FORMER CENTRAL RETAIL PARK
ROCHDALE
DESIGN & ACCESS STATEMENT
ADDENDUM

ORRD-LRW-XX-XX-PP-A-00624_P03 | JULY 2024

This Design and Access Statement Addendum has been prepared by Leach Rhodes Walker for Wilmott Dixon and Rochdale Development Agency in support of the non material amendment to the currently consented residential development in Rochdale approval reference:22/01119/FUL.

4 Bed House Rear and Side Elevation

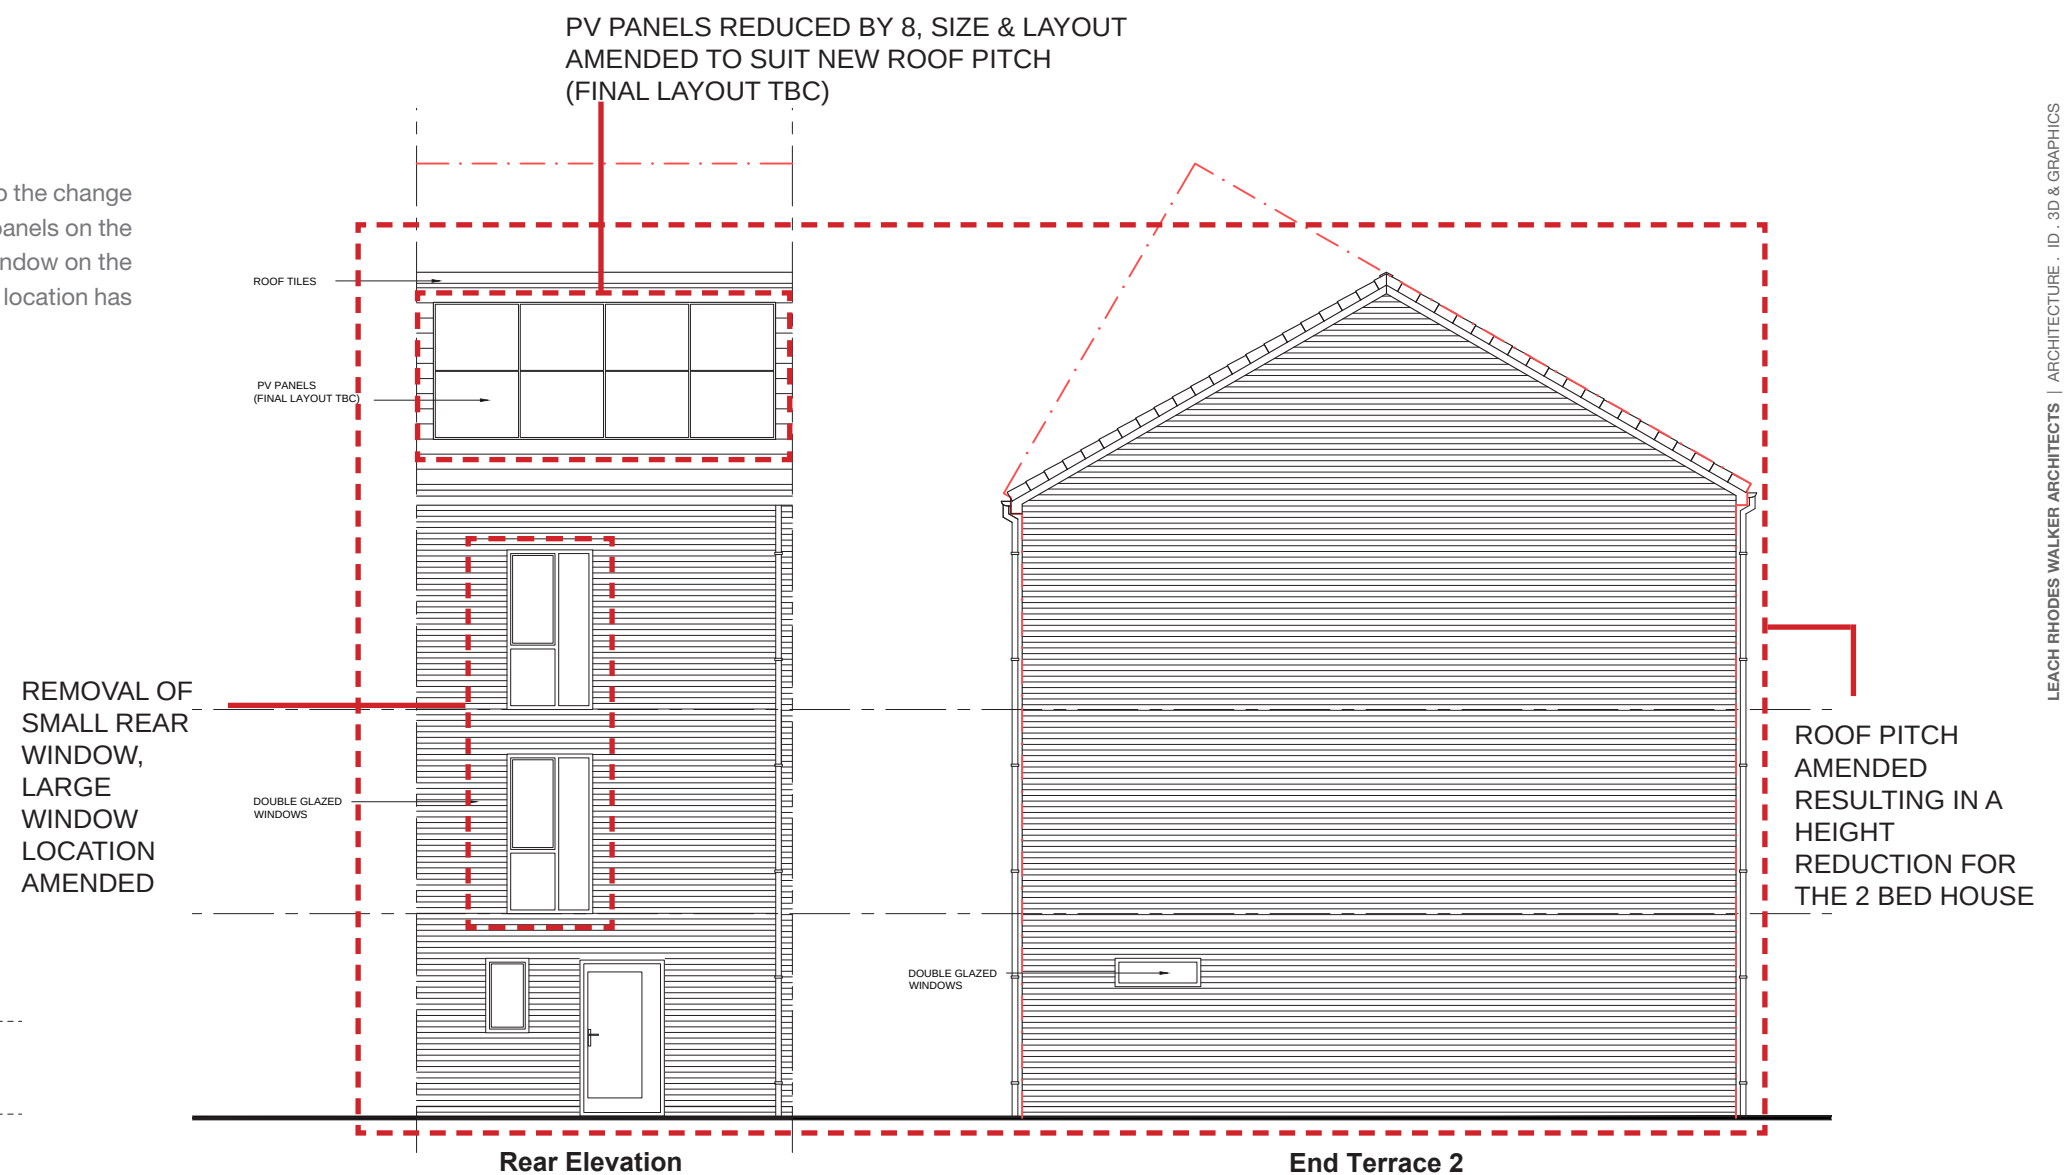
The 4 bed house rear and side elevation have reduced in height due to the change in roof pitch. This has impacted the amount, size and location of PV panels on the roof. As mentioned on the first and second floor layout the smaller window on the first floor of the rear facade has been removed, and the larger window location has been adjusted to sit more centrally within the bedroom.

Ground Floor Plan

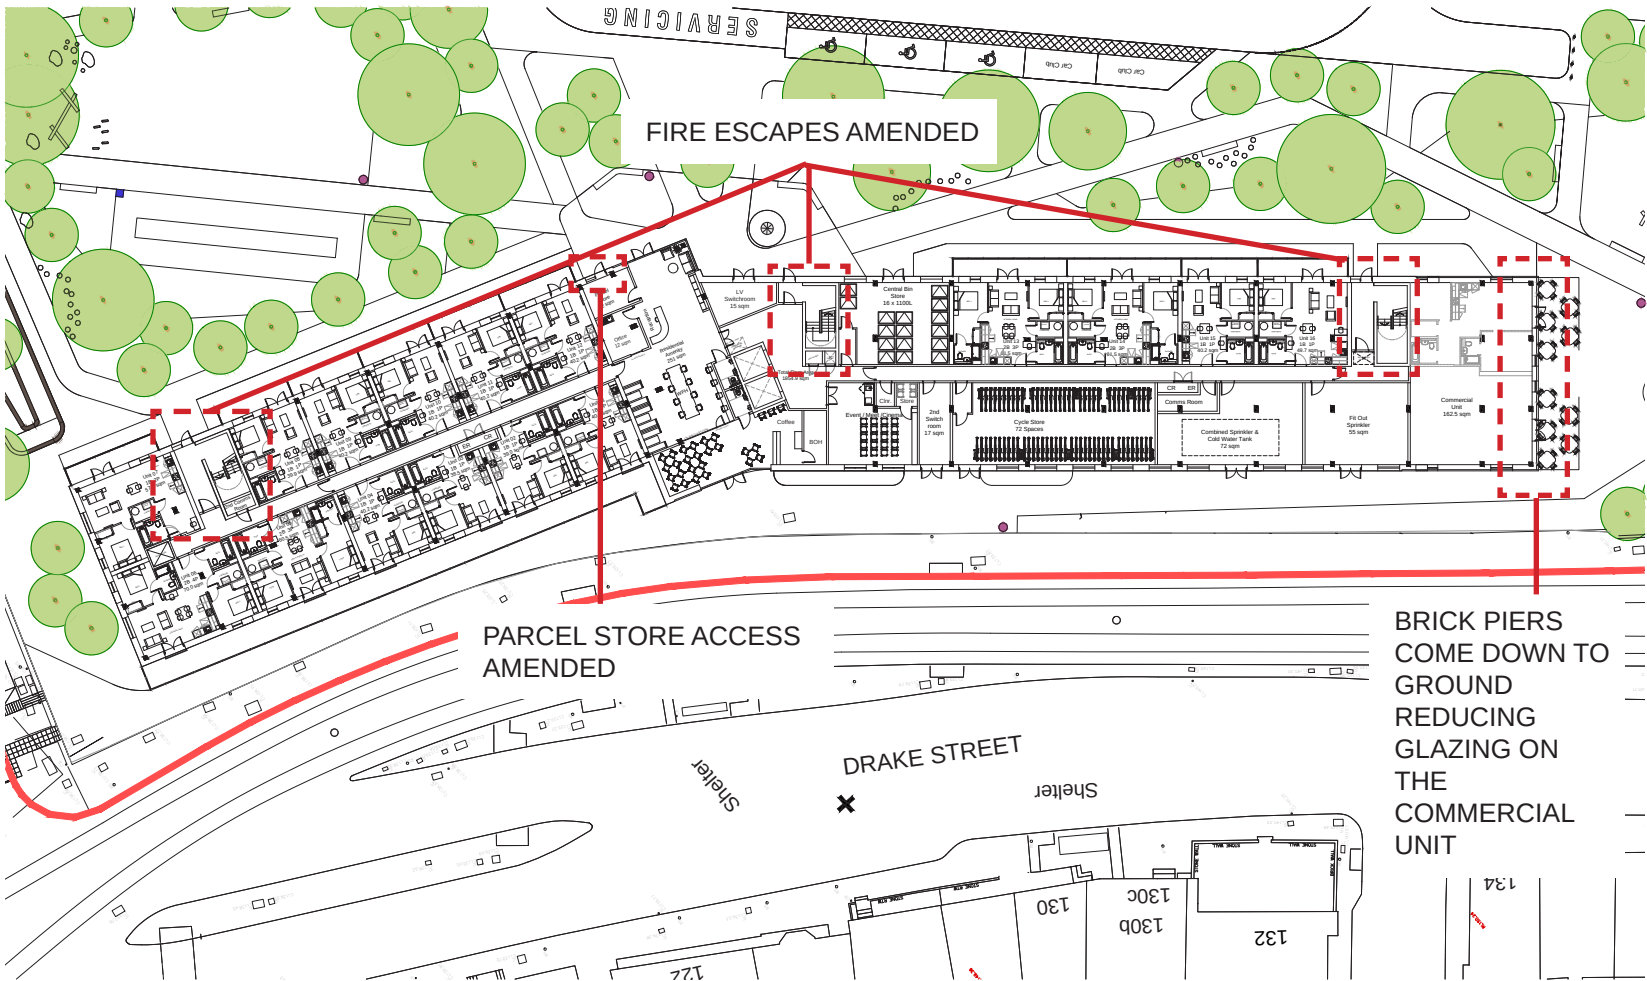
On the ground floor all the fire escapes have been amended by removing the first doorset in the core to create an unobstructed path and improve the route to safety for residents escaping from the building. The parcel store access has been amended to suit elevational changes the building. The brick piers come down to ground along the south elevation reducing the glazing to the commercial unit, this improves the flexibility of the layout if the operator adapted this space into an extra residential unit in the future.

Typical Floor Plan (1st-4th)

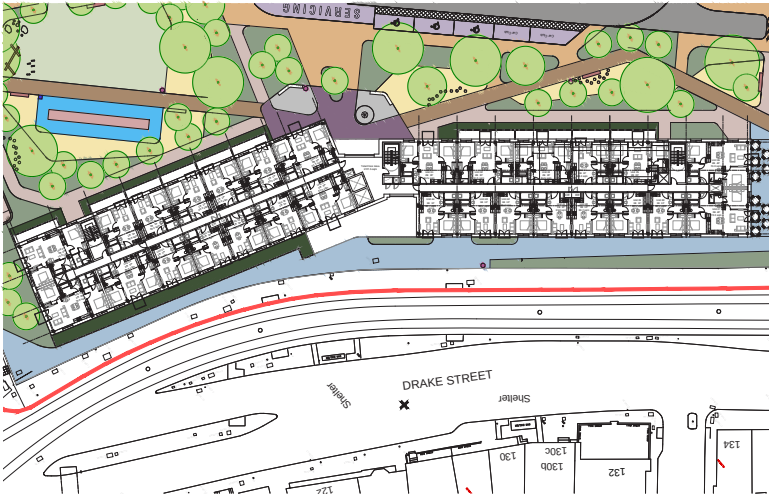
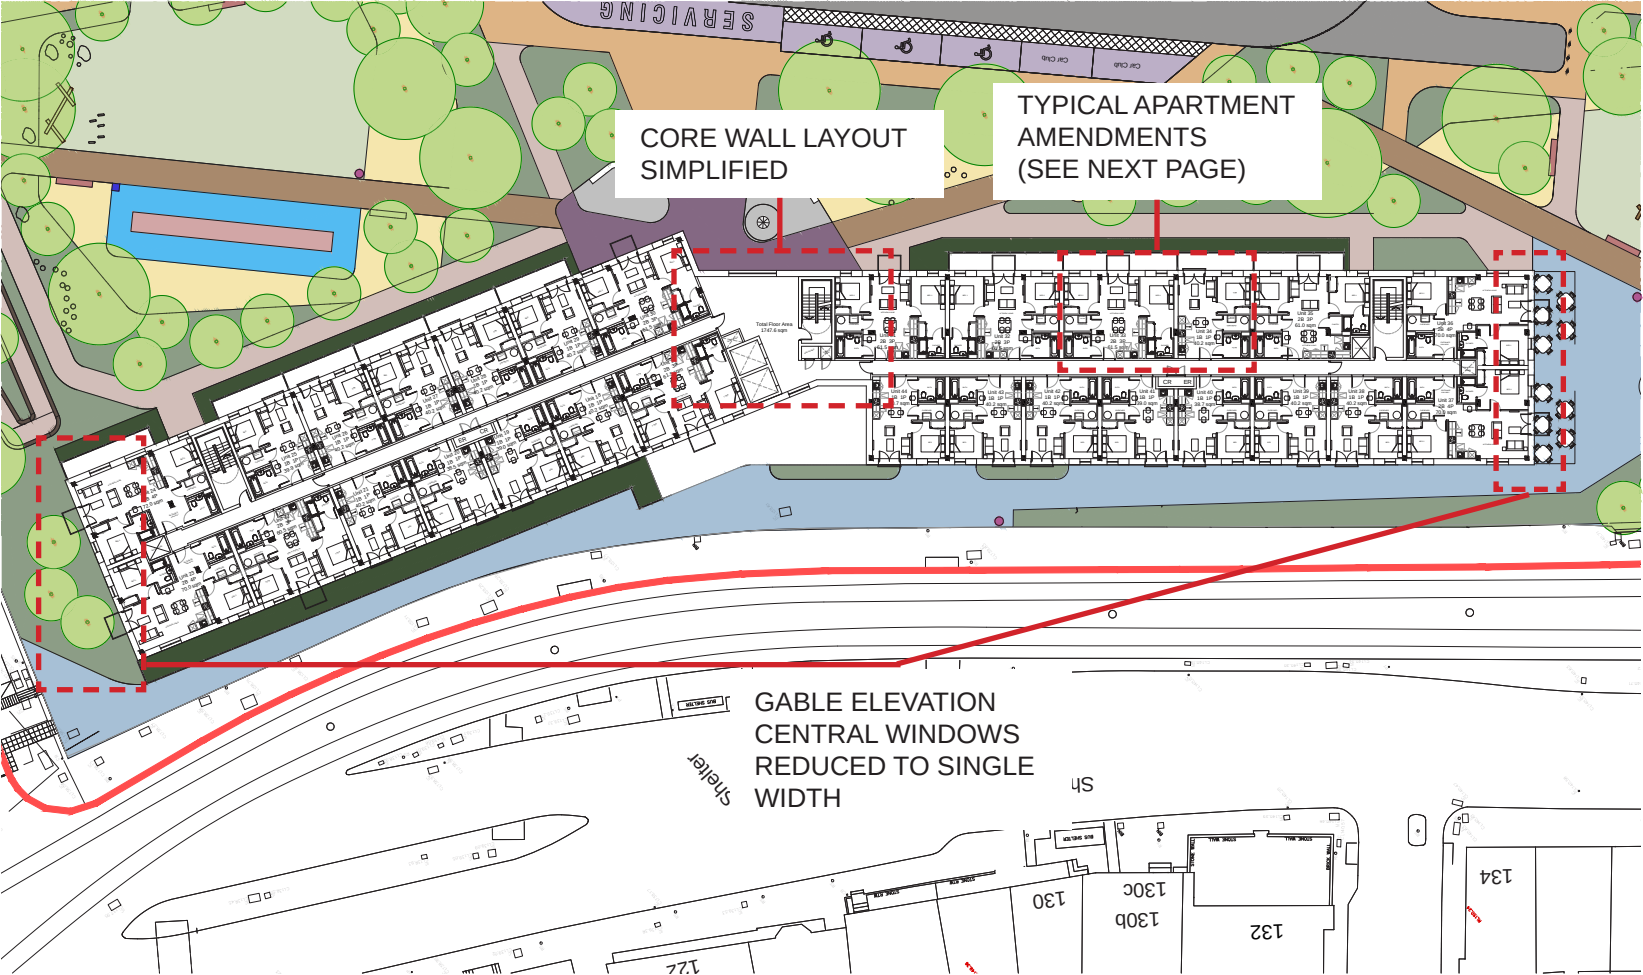
On the typical floor the walls around the central core have been simplified to improve buildability. Also, the two gable ends have been amended to show single bedroom windows on the elevation. For amendments to the typical apartments see the next page.

Typical Floor Plan (1st-4th)

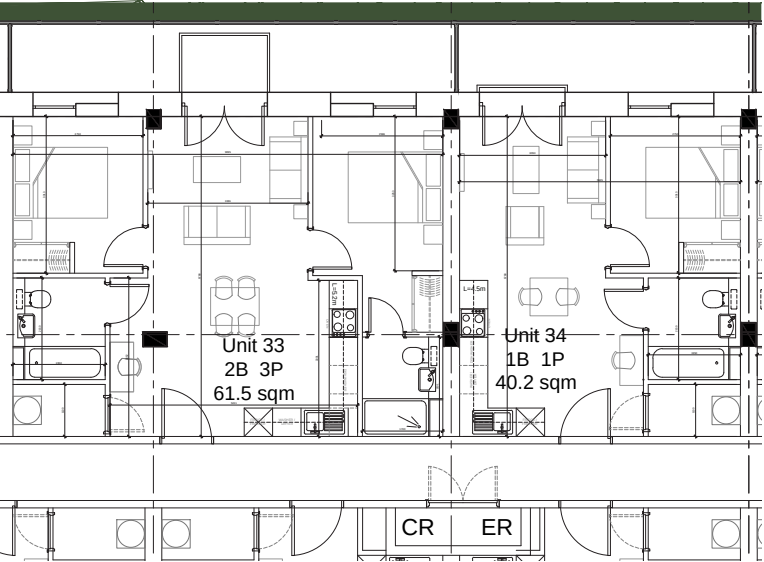
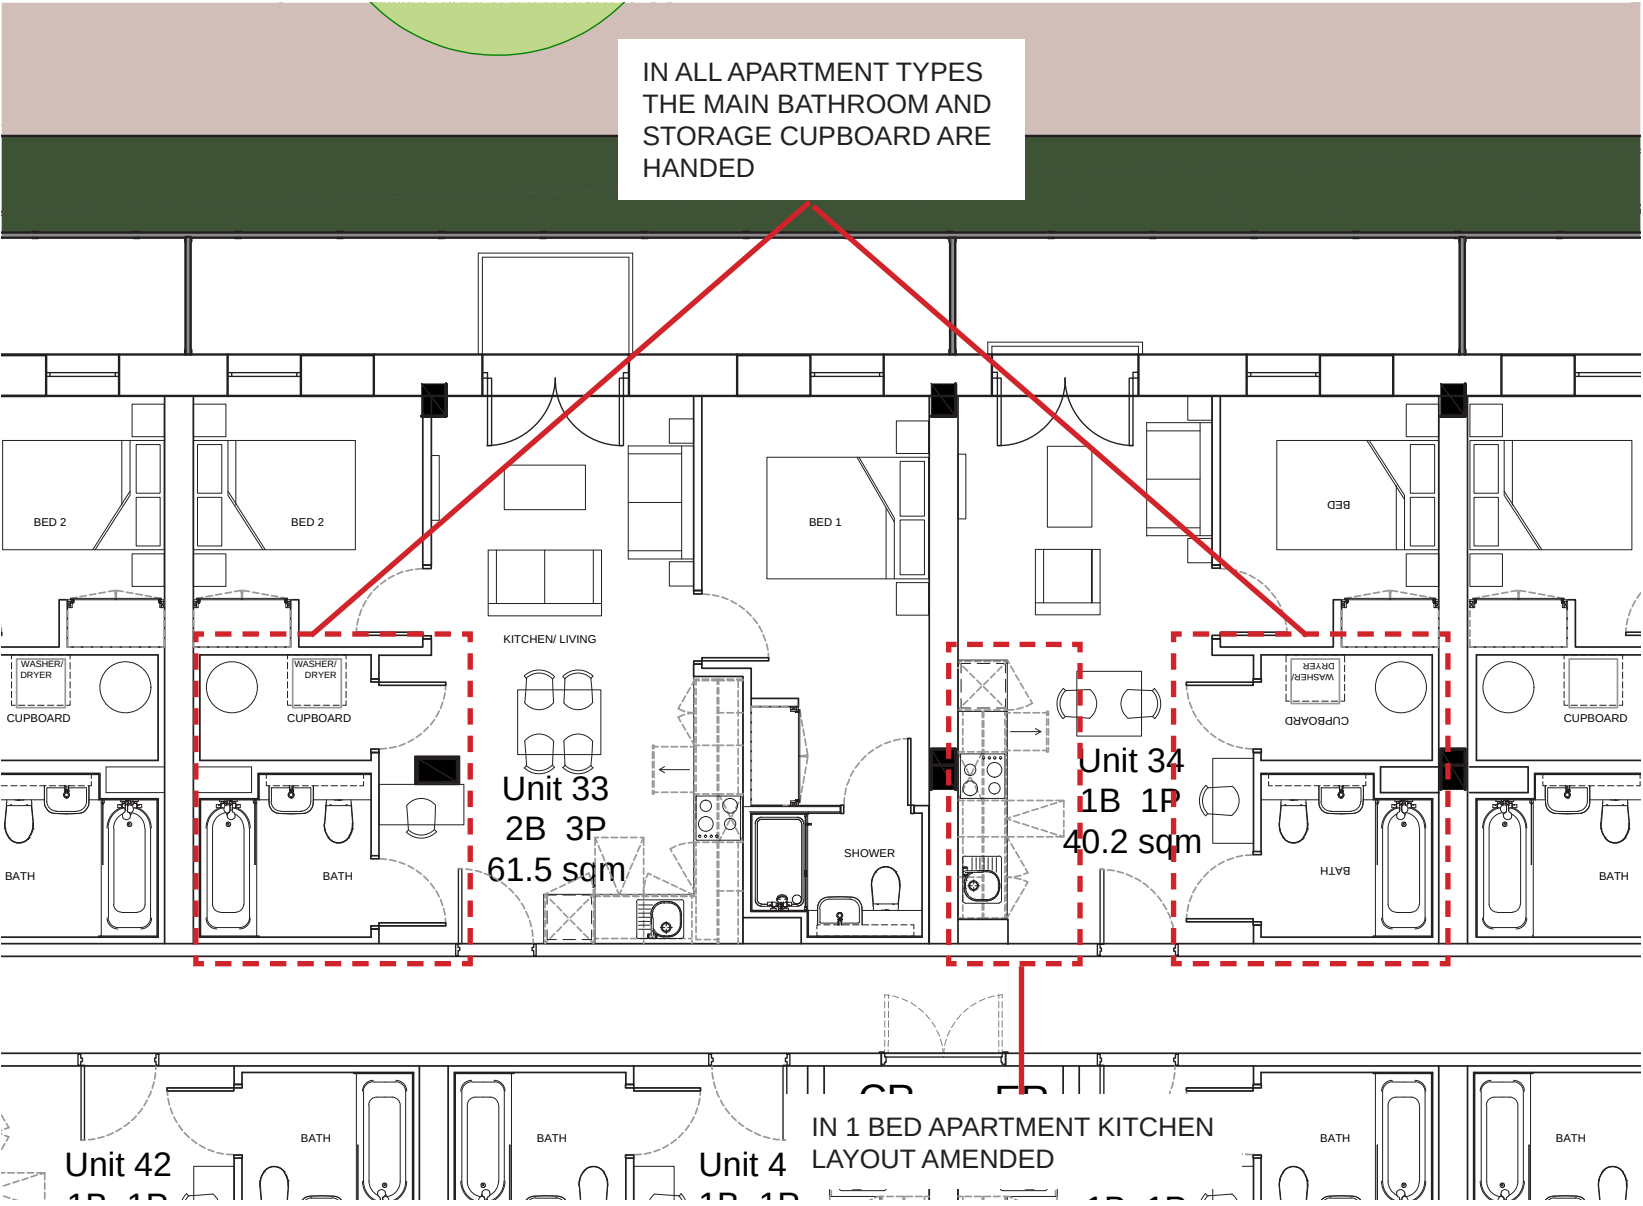
The apartments have had an internal layout amendment that has resulted in handing the cupboard with the bathroom. The 1 bed apartment kitchen layouts have also been amended from a corner layout to a straight run.

Fifth Floor Plan

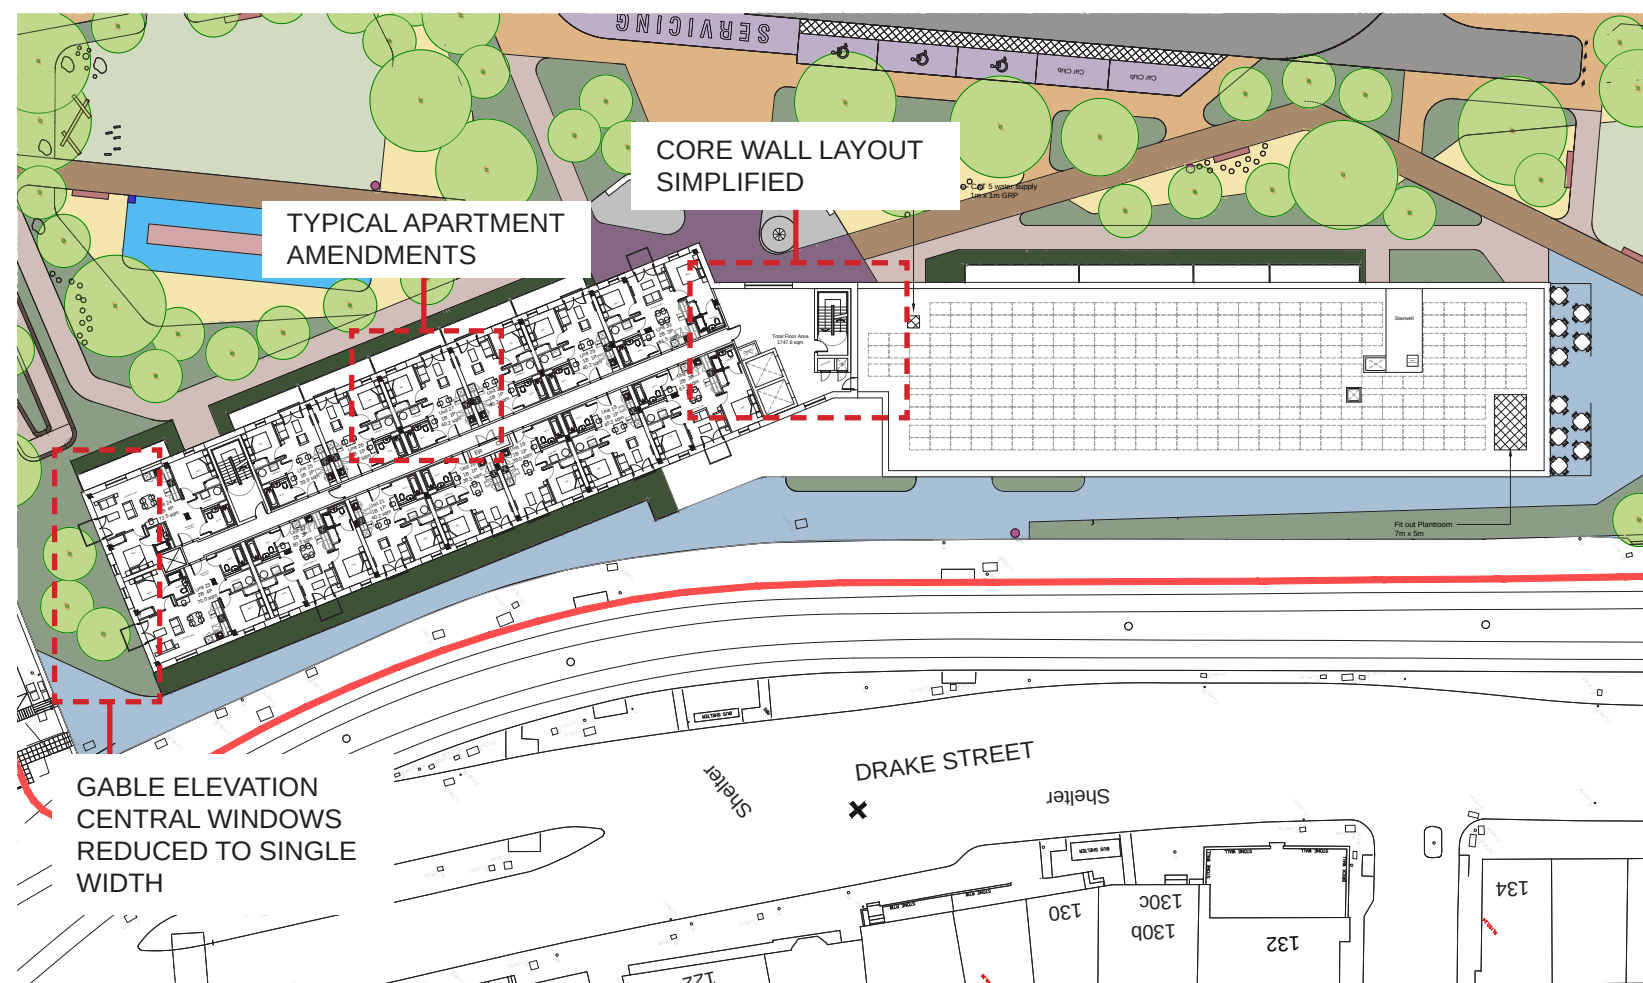
On the fifth floor the amendments from the lower floors are continued including the core wall simplification, the single bedroom windows on the gable elevation and the typical apartment amendments from the previous page.
